PLANS OF PROPOSED IMPROVEMENT ON THE
PRIMARY ROAD SYSTEM
POLK COUNTY
PCC Pavement Widening
Des Moines River to 500 ft N of Maury Ave in Des Moines

NHSN-069-4(110)--2R-77

DMWW U3 First Plan Review Comments Sent 1/28/25.
For questions or comments please contact the following:

D5 PLAN - Date: 07-19-24

FILE NO.	ENGLISH	DESIGN TEAM Iowa DOT / HR Green	POLK COUNTY	PROJECT NUMBER NHSN-069-4(110)--2R-77	SHEET NUMBER E.3
----------	---------	---------------------------------	-------------	---------------------------------------	------------------

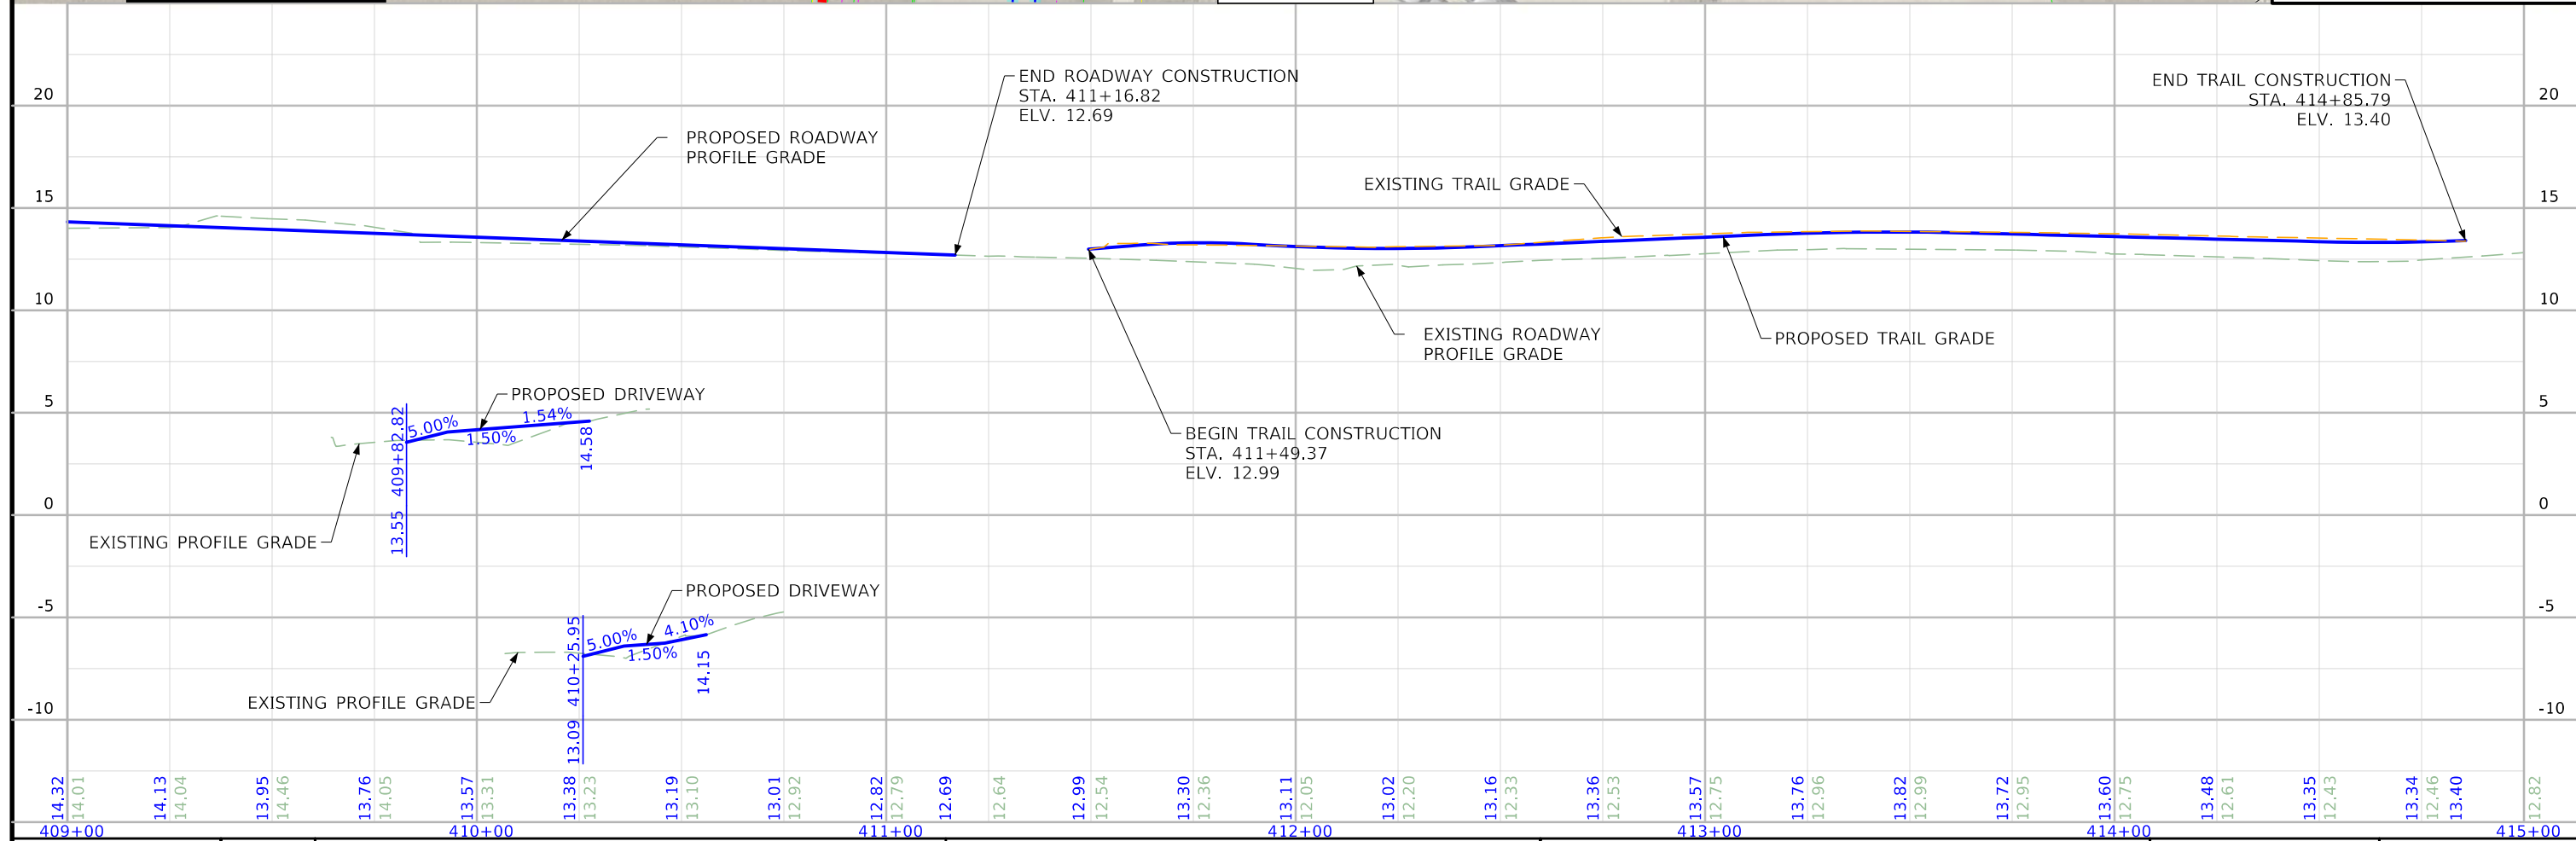
Show the existing 48" PCCP Feeder Main on the plans. Design team will need to call in survey locates and coordinate depth checks with DMWW. Potholing to locate feeder main is required for design and construction.

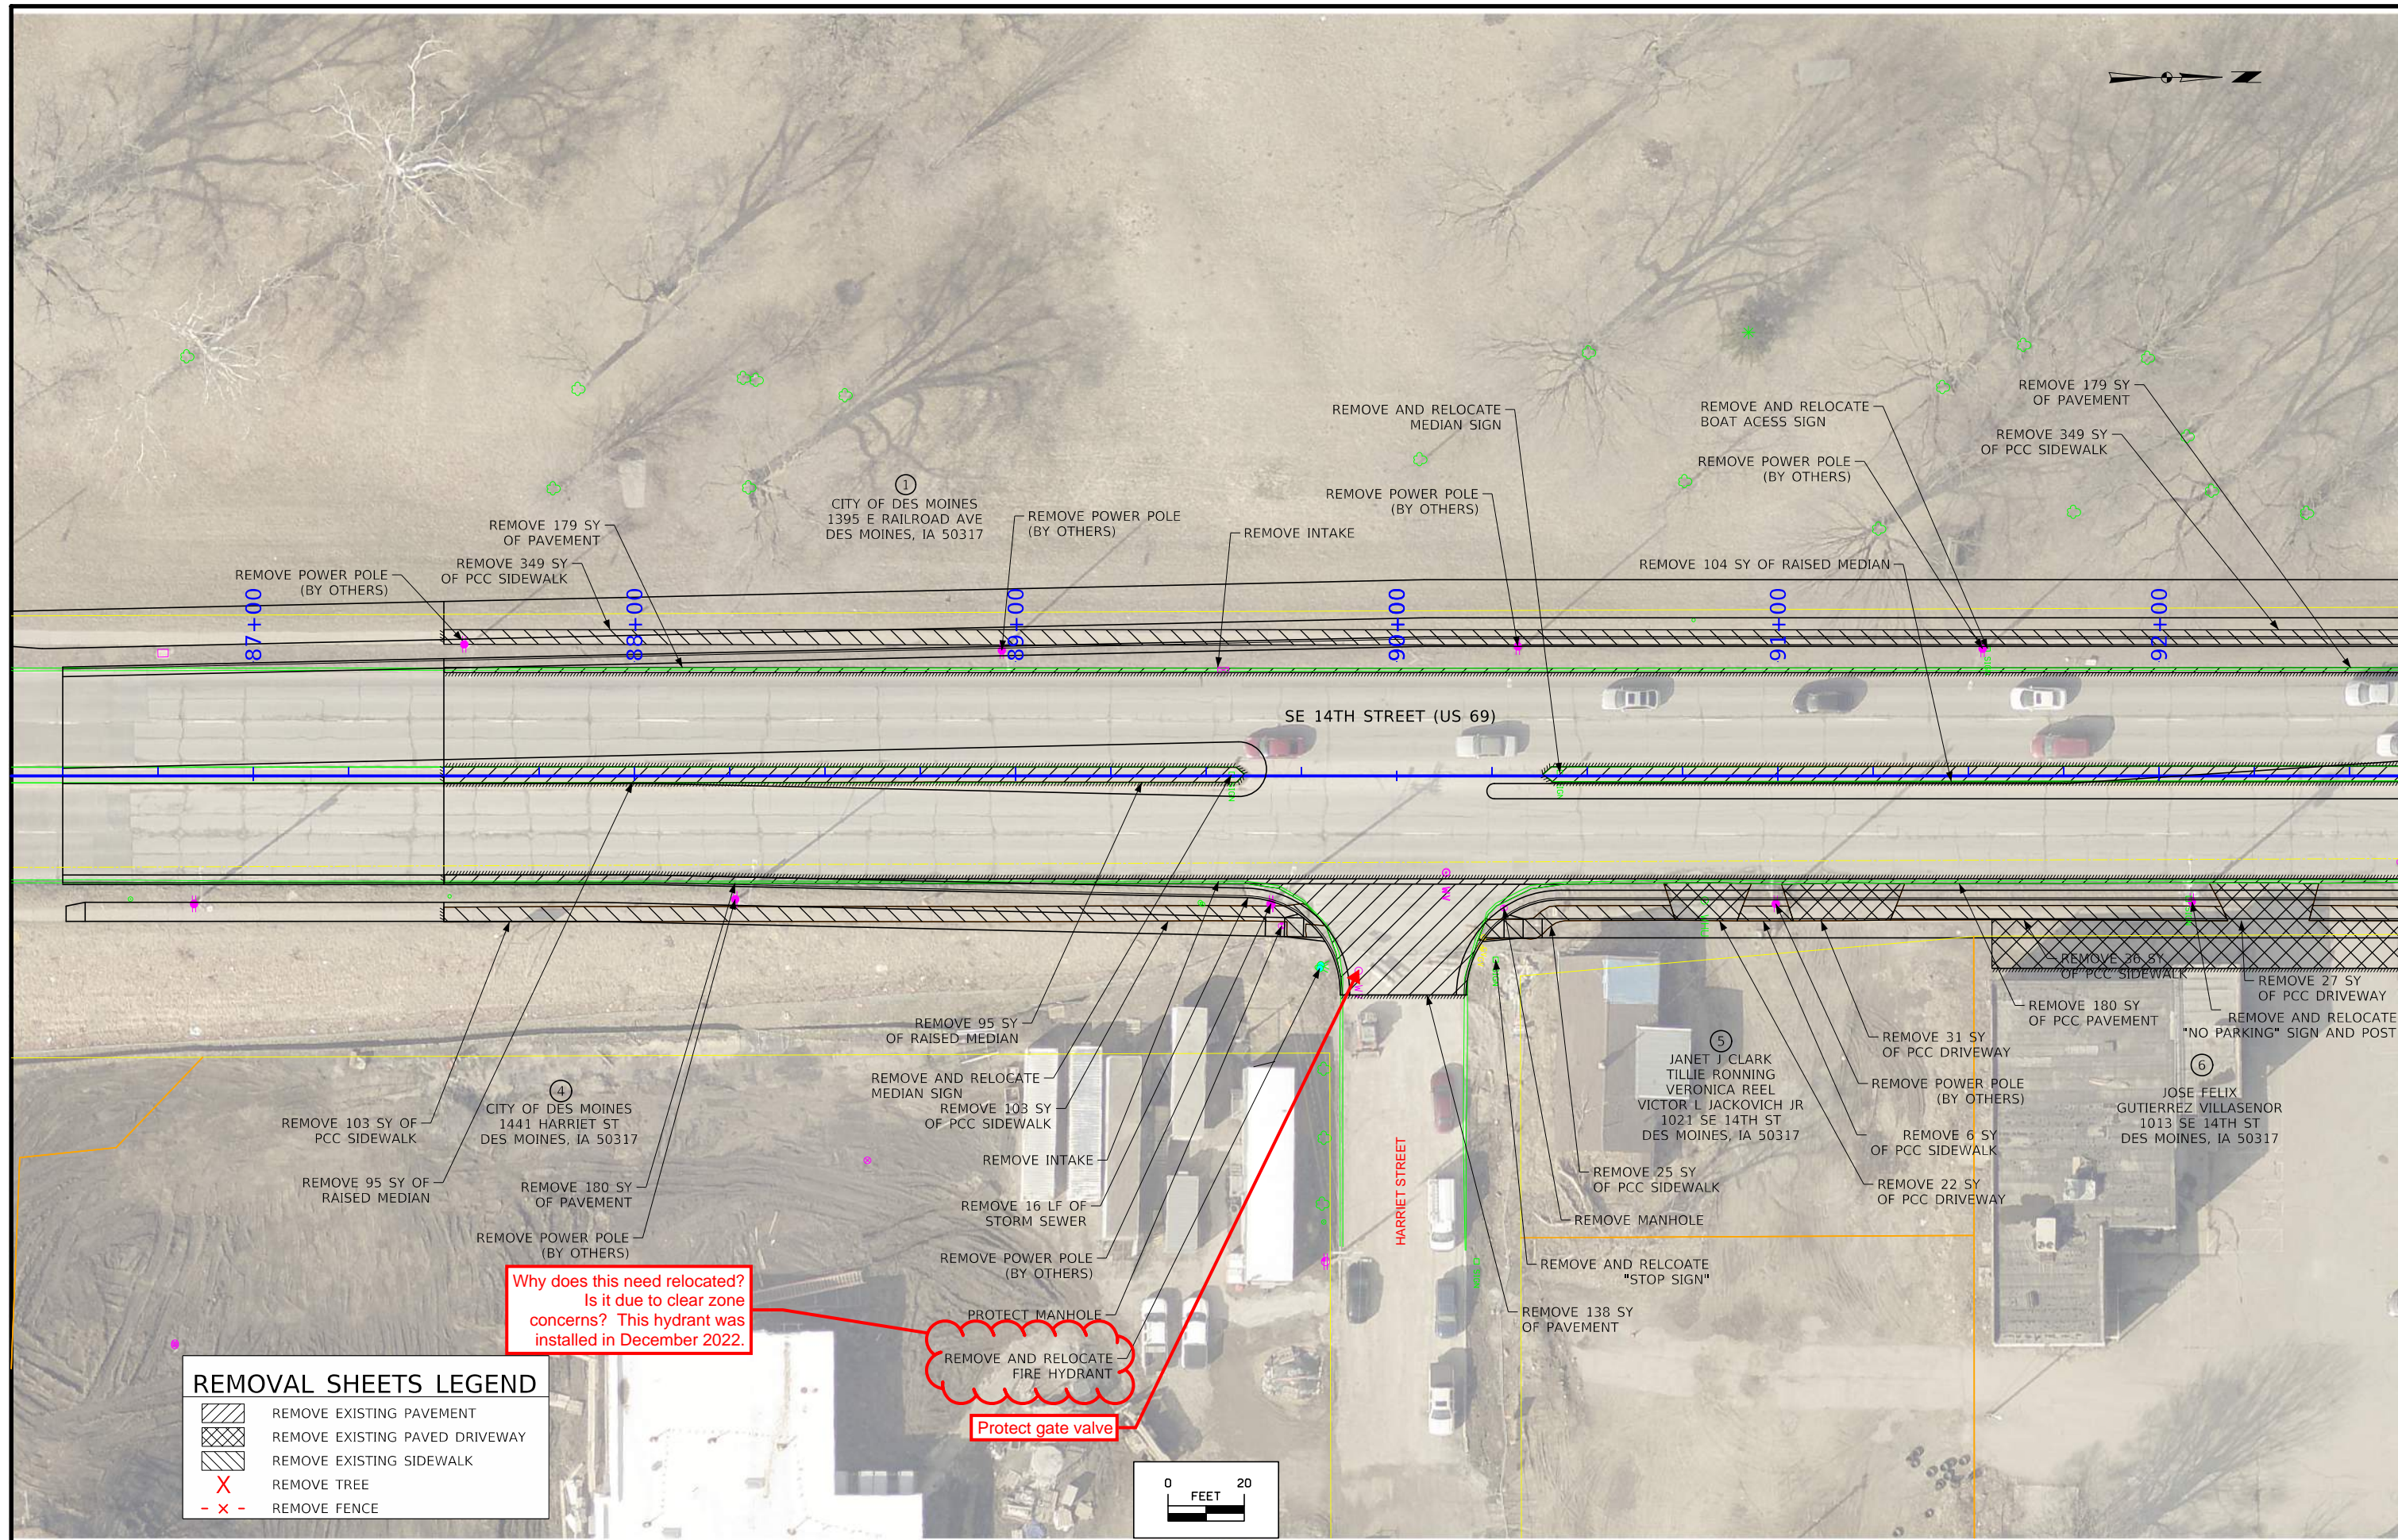
Why does this need relocated?
Is it due to clear zone concerns? This hydrant was installed in December 2022.

Protect gate valve

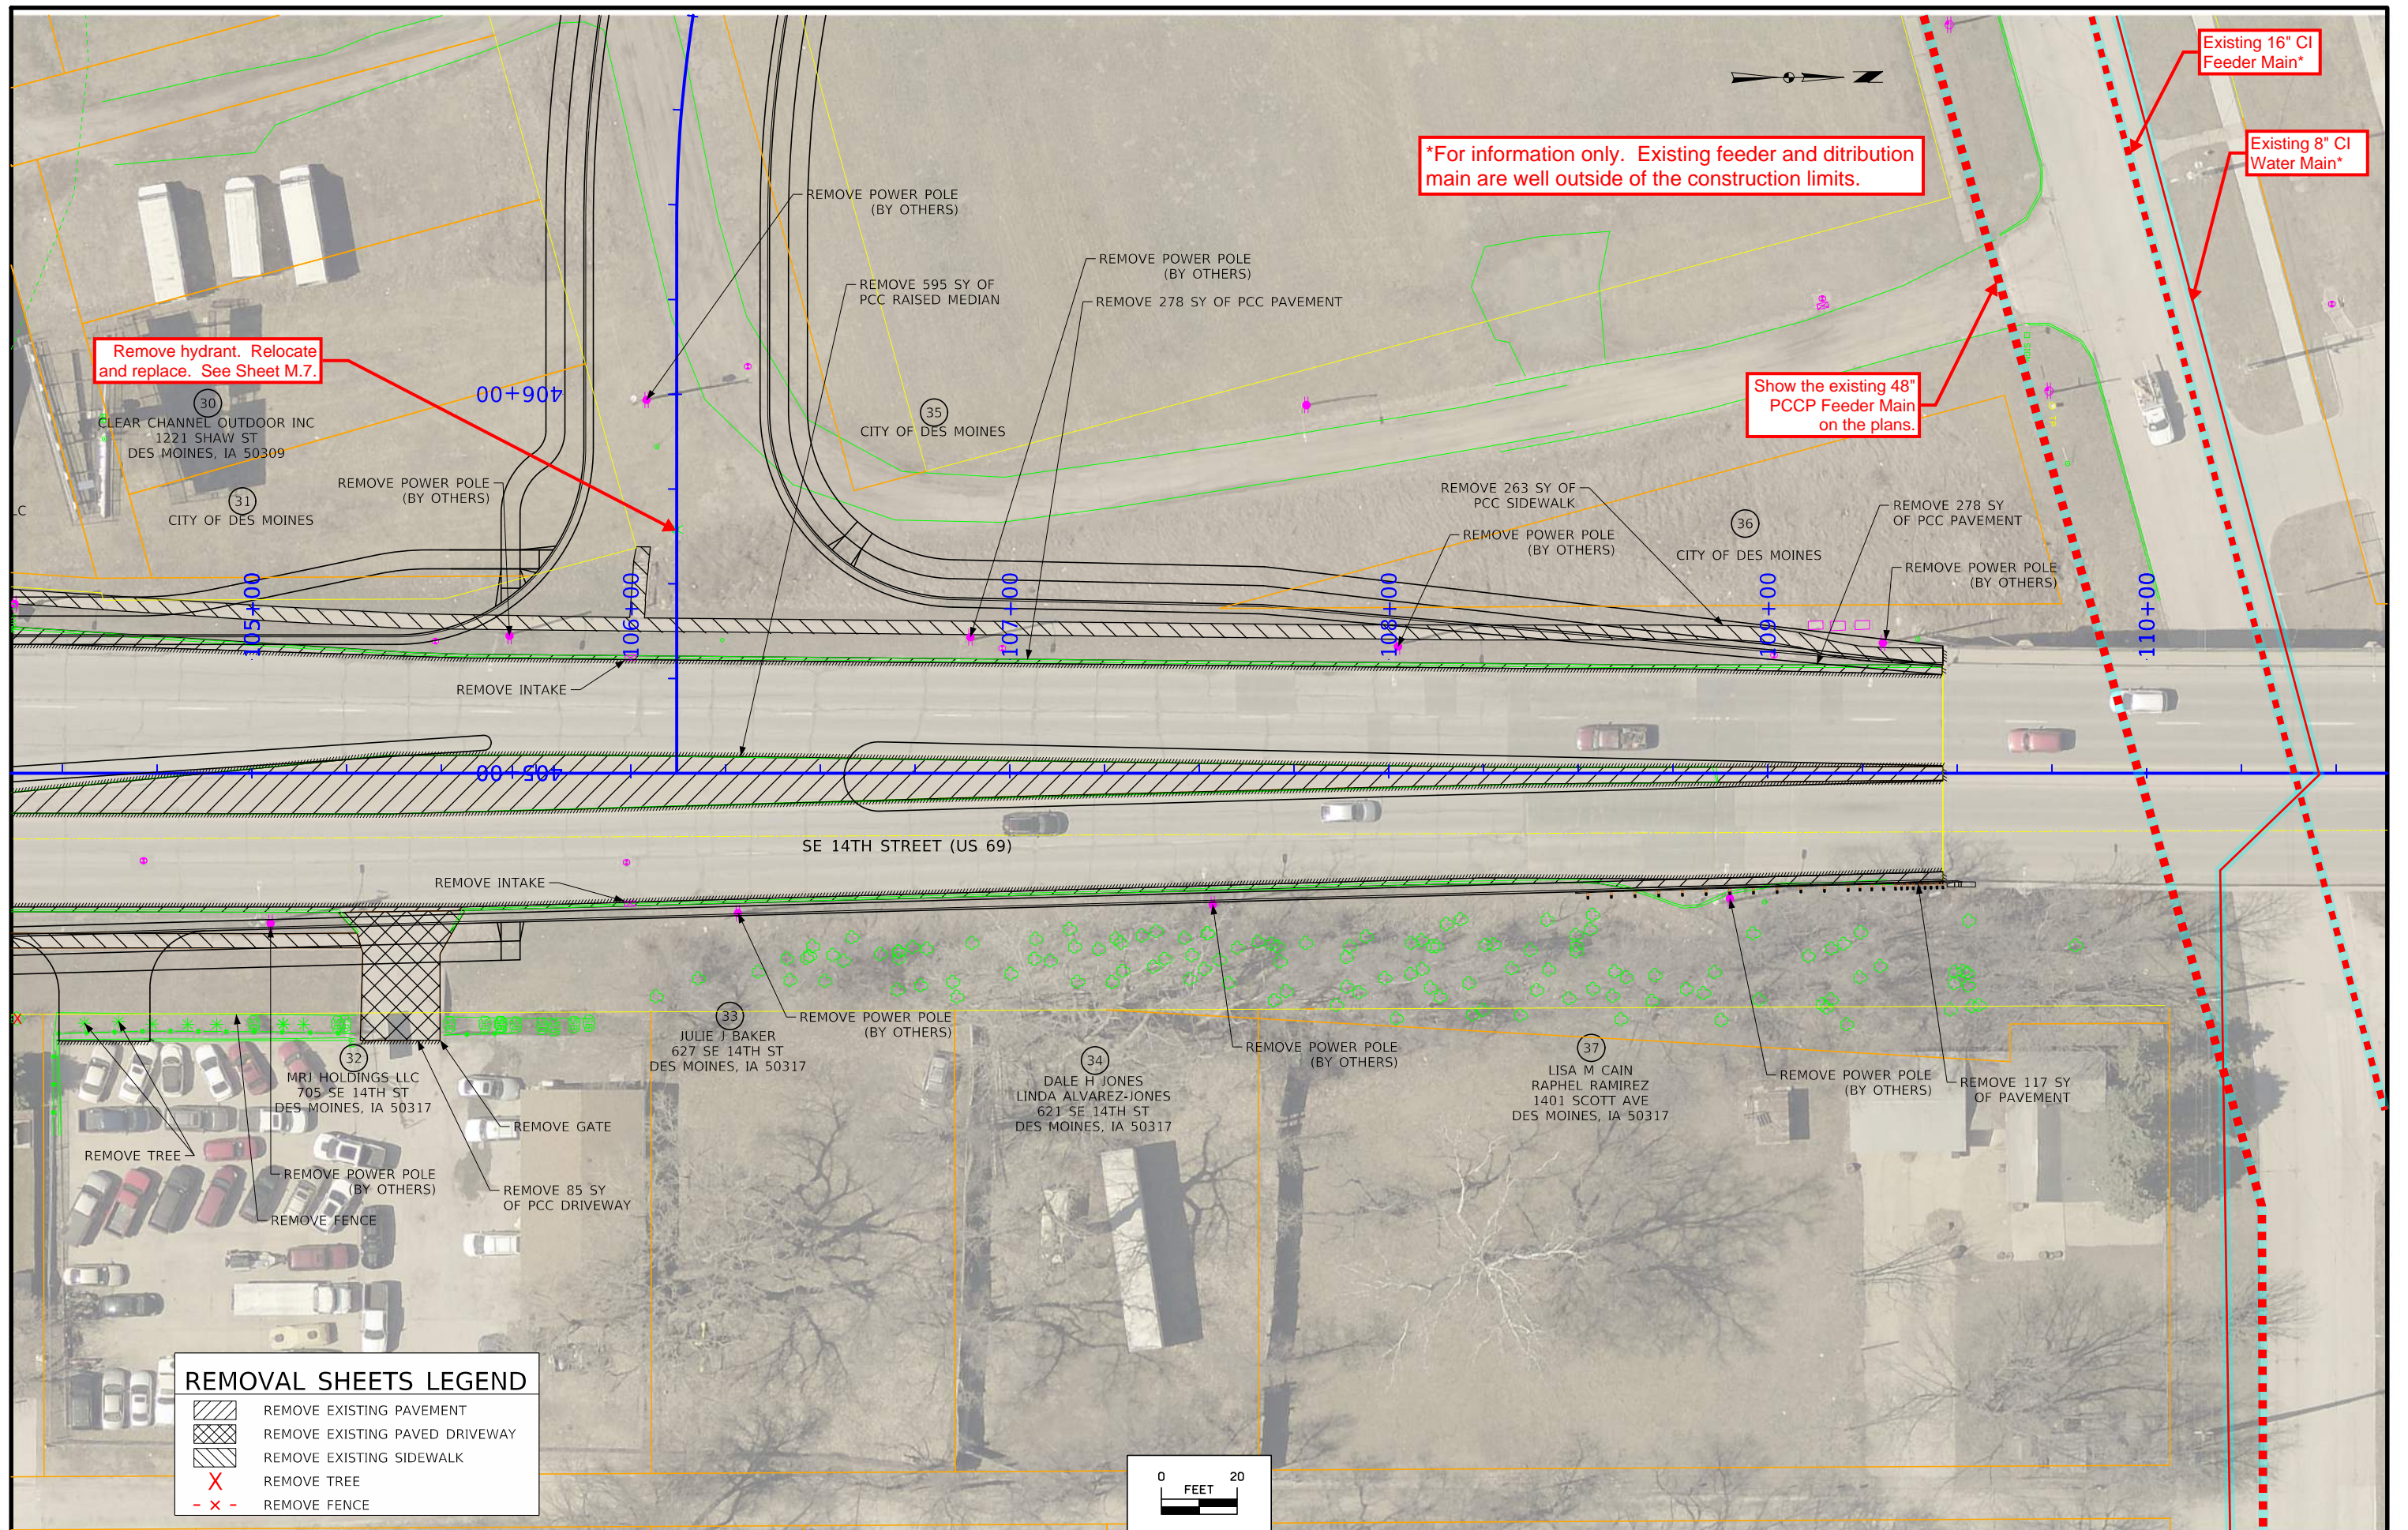
*For information only. Existing feeder and distribution main are well outside of the construction limits.

Show the existing 48" PCCP Feeder Main on the plans.

Existing 16" CI Feeder Main*

Existing 8" CI Water Main*

Remove hydrant. Relocate and replace. See Sheet M.7.
